Project	IEEE 802.16 Broadband Wireless Access Working Group < <a href="http://ieee802.org/16">http://ieee802.org/16</a> >	
Title	Improved CTC Performance	
Date Submitted	2005-01-10	
Source(s)	T. Keith Blankenship Yufei Blankenship Brian Classon Motorola	keith.blankenship@motorola.com yufei.blankenship@motorola.com brian.classon@motorola.com
Re:	IEEE P802.16-REVe/D5a, BRC recirc	
Abstract	This contribution demonstrates that the convolutional turbo code (CTC) interleavers for block sizes 120 bytes and above have performance deficiencies. By selecting different interleaver parameters for these block sizes, the deficiencies can be corrected. The performance improvement in AWGN at $10^{-4}$ FER with the new parameters is at least 0.5 dB and in some cases up to 1.3 dB.	
Purpose	To provide improved CTC channel coding interleaver parameters when supporting H-ARQ with 802.16e units.	
Notice	This document has been prepared to assist IEEE 802.16. It is offered as a basis for discussion and is not binding on the contributing individual(s) or organization(s). The material in this document is subject to change in form and content after further study. The contributor(s) reserve(s) the right to ad

Figure 1. FER performance for currently specified CTC interleavers.

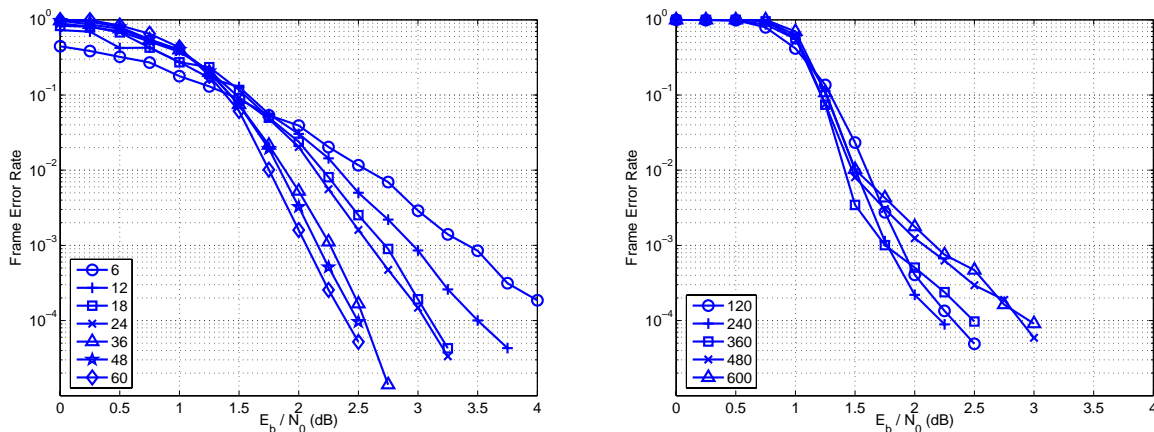
The performance of the  $6n$ -byte block sizes displays the expected turbo code behavior of improving performance with increasing block size. Furthermore, no error floor is discernable down to a FER of  $10^{-4}$ . However, the performance of the  $120n$ -byte block sizes displays the opposite. Here, the performance degrades with increasing block size (above 240-byte) and a distinct error floor is present.

Figure 2. Performance with new CTC interleaver parameters.

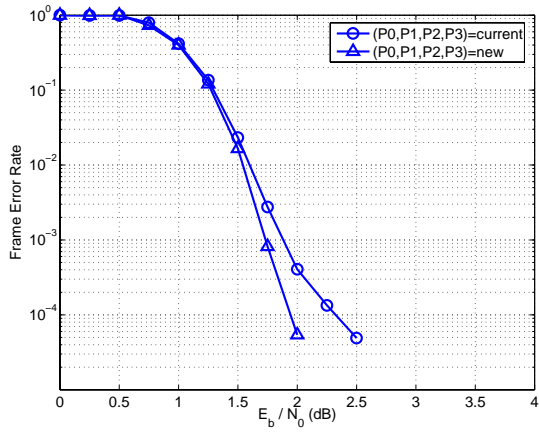
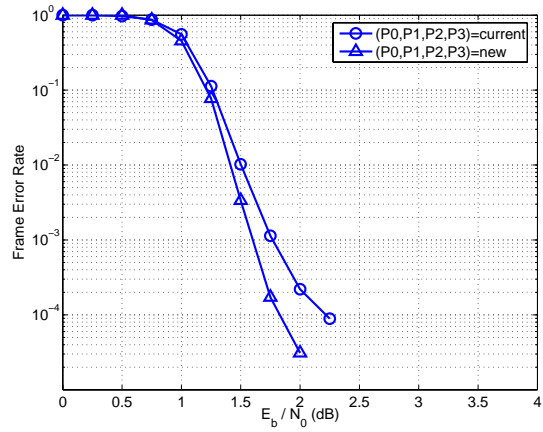
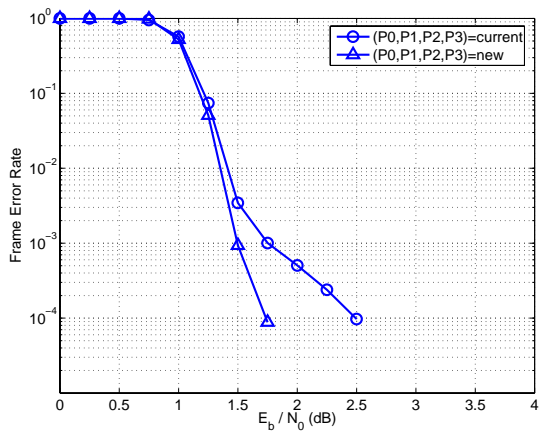
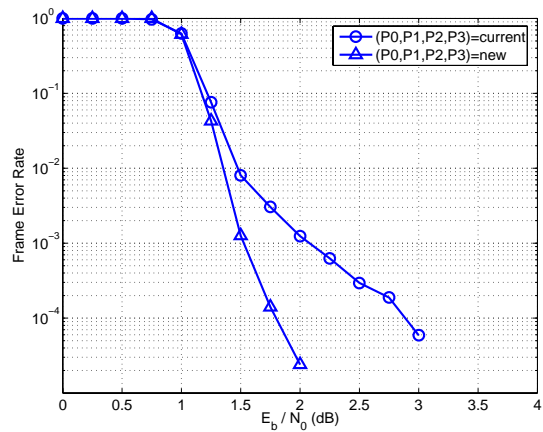
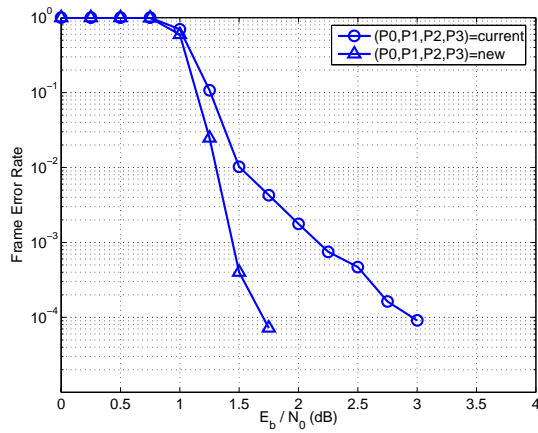
A new set of CTC interleaver parameters was designed to correct the performance deficiencies of the  $120n$ -byte block sizes. The new parameters were selected according to guidelines prescribed in [1]. The FER performance (rate-1/2, binary modulation, static AWGN channel, 7.5 decoding iterations, and “genie” circulation state knowledge) with the new parameters is plotted in Figure 2. The figure shows that the new parameters correct the performance deficiencies of the current parameters. At  $\text{FER} = 10^{-4}$  the performance with the new parameters is at least 0.5 dB and in some cases up to 1.3 dB better than with the current parameters.

Table 325a – Optimal CTC channel coding per modulation when supporting H-ARQ

<b>Data block size (bytes)</b>	<b>N</b>	<b>P0</b>	<b>P1</b>	<b>P2</b>	<b>P3</b>
6	24	5	0	0	0
12	48	13	24	0	24
18	72	11	6	0	6
24	96	7	48	24	72
36	144	17	74	72	2
48	192	11	96	48	144
60	240	13	120	160	180
120	480	<del>13</del> 53	<del>240</del> 62	<del>120</del> 12	<del>360</del> 2
240	960	<del>13</del> 43	<del>480</del> 64	<del>240</del> 300	<del>720</del> 824
360	1440	<del>17</del> 43	720	360	540
480	1920	<del>17</del> 31	<del>960</del> 8	<del>480</del> 24	<del>1440</del> 16
600	2400	<del>17</del> 53	<del>1200</del> 66	<del>600</del> 24	<del>1800</del> 2
